VEHICLE RECALL

G-02515 December 2002

SUBJECT: VEHICLE RECALL (U.S., EXPORT)

Under-Torqued Brake Spider or Anchor Plate

Figure 2 – Rear Spider Mounting

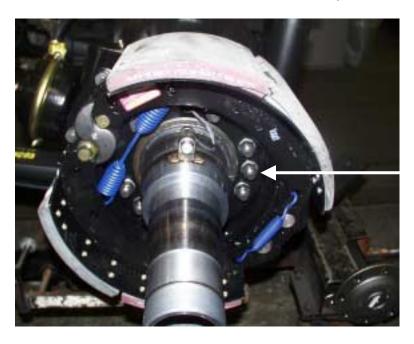
- 1. Remove rear wheel assembly (rim and tire).
- 2. Install cage bolt into park brake air chamber.
- 3. Loosen rear brake shoe adjustment.
- 4. Remove rear brake drum (or hub).
- 5. Remove one brake spider fastener to determine if there is any indication of brake spider chucking (wear marks on the bolts or brake spider caused by movement of the brake spider on the axle); if so, all brake spider mounting fasteners must be replaced (Reference Figure 2). Reference the PART INFORMATION section of this letter for replacement fasteners.

Rear Spider Mounting Bolts 9 or 10 Per Wheel End With Washers

- 6. Torque ALL (9 or 10) rear brake spider bolts to 175 190 Lbf-Ft (240 260 NM).
- 7. Install rear brake drum (or hub).
- 8. Adjust outer wheel bearing adjusting nut and check end play with dial indicator.
